Hume Coal Project and Berrima Rail Project

*State Significant
Development Assessment
(SSD 7172 and SSD 7171)*

December 2018

The Wongawilli coal seam in this area is relatively shallow at depths of 70 to 180 m. While the seam is typically 10 m thick in the Southern Coalfield, the seam has been eroded in the project area and ranges from completely missing to 8.5 m thick.

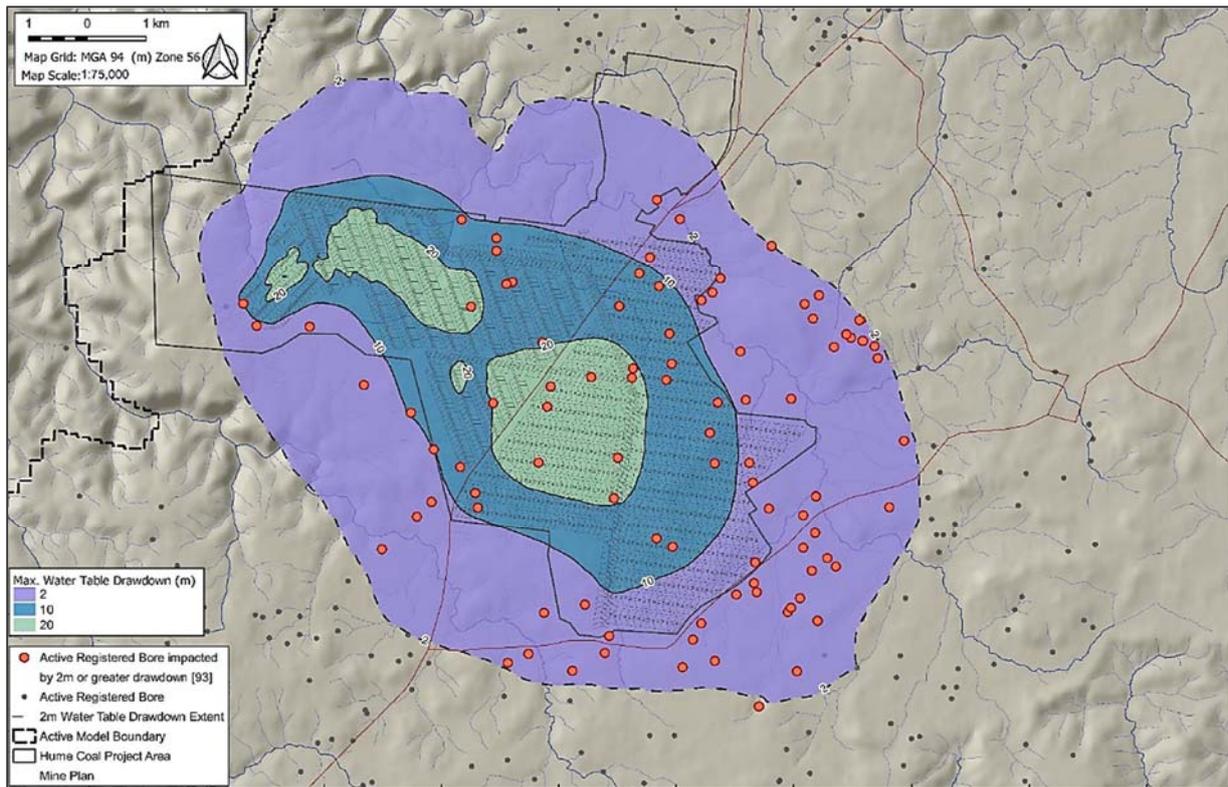
The Department has summarised the predicted drawdown impacts on privately owned bores in **Table 7**, including both the 67th percentile and 90th percentile predictions (where available). A map of the privately-owned bores that are predicted to experience a drawdown of greater than 2 m is provided in **Figure 10**.

While the *Aquifer Interference Policy* defines more than a ‘minimal impact’ as over 2 m, there are a substantial number of bores with predicted drawdown much greater than that (e.g. 54 bores with more than 5 m). **Table 8** summarises the number of the affected bores per depth of impact (at the 67th percentile).

Figure 11 | Project drawdown and proposed 'make good' provisions

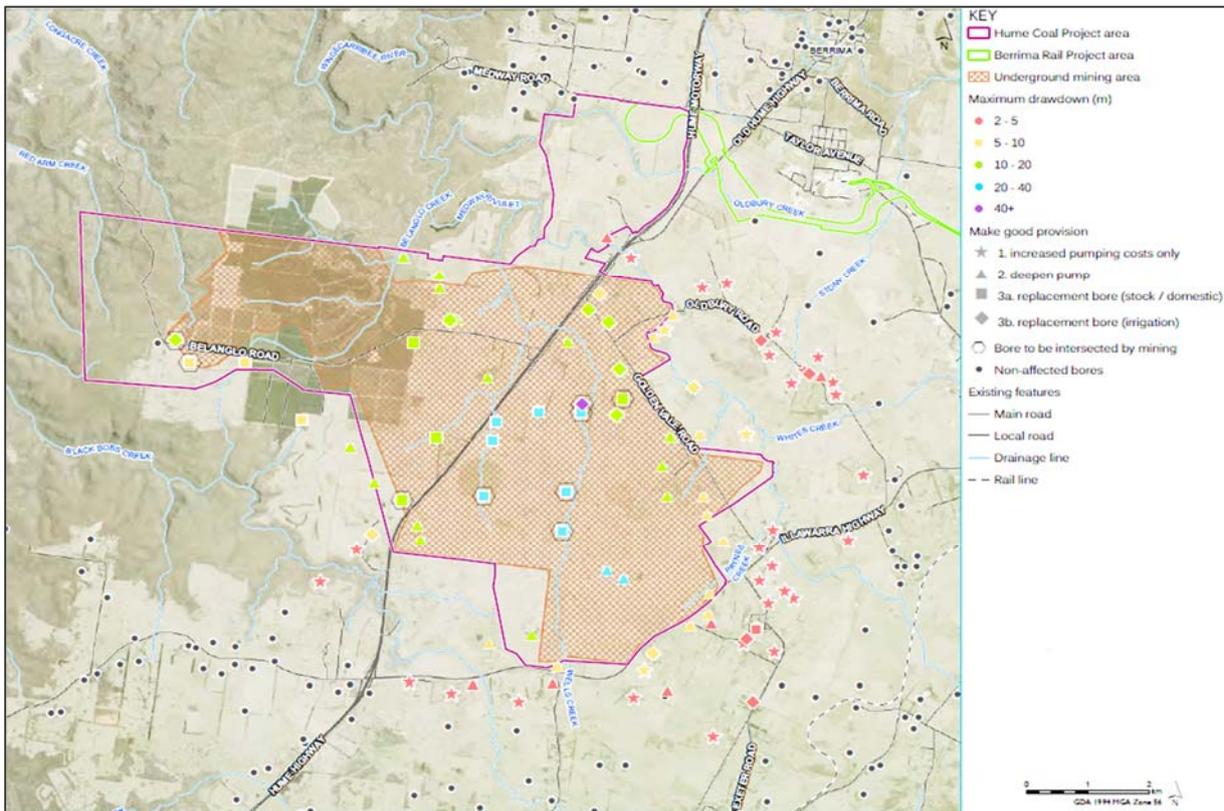
The 'preliminary make good assessment' has provided an indication of the options that would be required for each of the 94 bores that are predicted experience an impact (based on the 67th percentile probability), which is summarised in **Table 9** and depicted in **Figure 11**.

While Dol Water also did not raise any major concerns about the technical feasibility of the proposed options, it highlighted the difficulties associated with replacing bores. It noted that the "*viability of providing an alternate water supply for irrigation activities has not been confirmed with 15 irrigation bores identified as requiring replacement*". The Applicant has also acknowledged that it may not be "*physically possible to deepen (i.e. within the existing bore) for many bores for various reasons*".

While the Department agrees that the options of deepening or replacing bores may present challenges, the Department generally accepts that the Applicant's proposed make good options are technically feasible.

Figure 12 | Pillar types in the 'pine feather' mining method

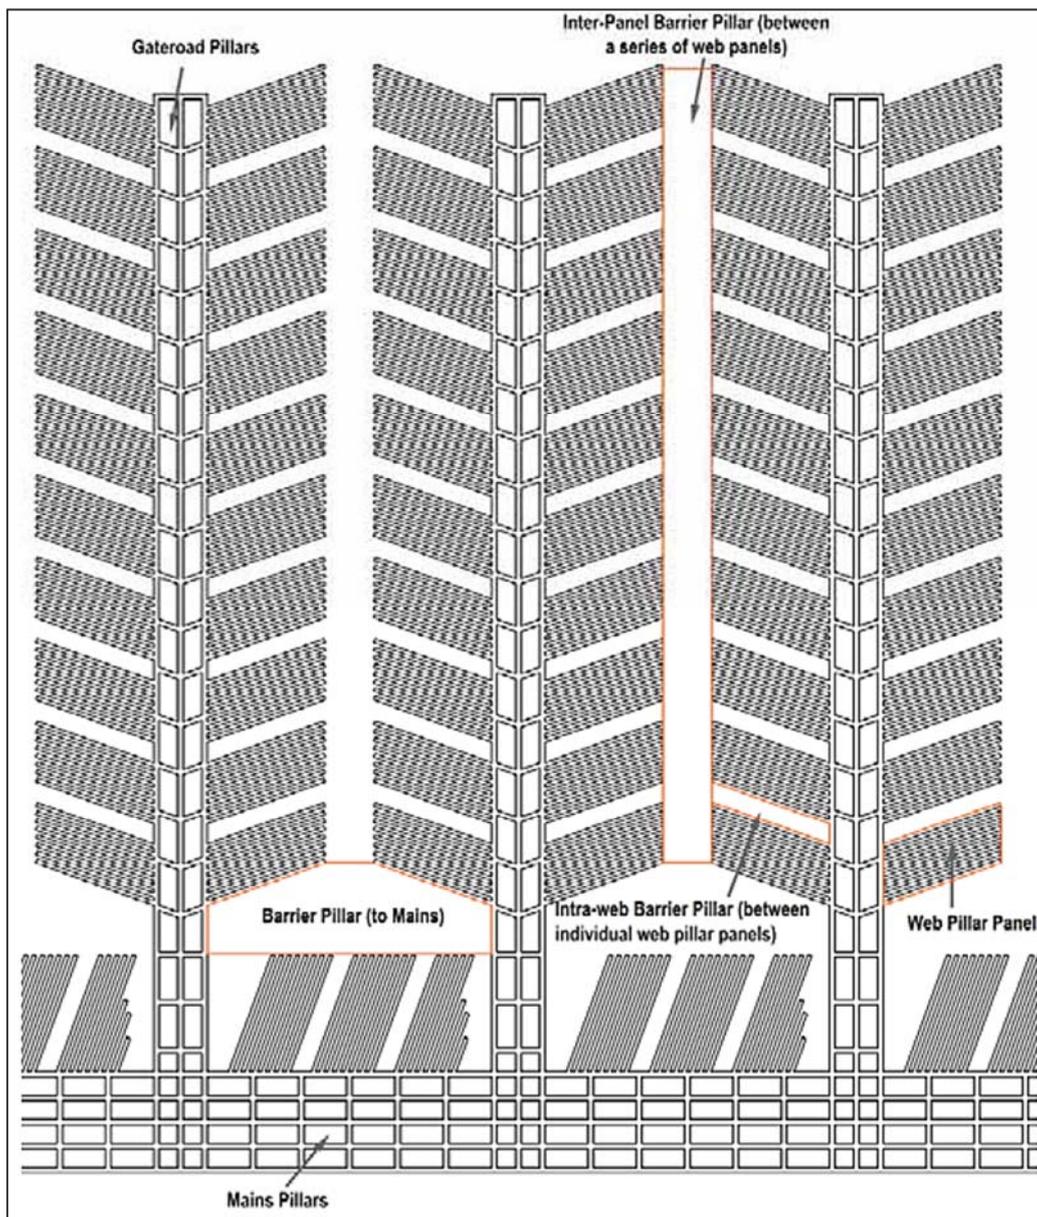
However, an important aspect of the 'pine feather' mining method is the use of a variety of other types of pillars (see **Figure 12**), including:

In summary, the proposed pine feather mining method is unique to NSW and Australia. While it has some similarities to underground bord and pillar mining and above-ground highwall mining, there are some significant differences to each of these methods. The proposed mining method relies on a range of pillars, and the stability of these pillars is a fundamental consideration in assessing potential impacts.
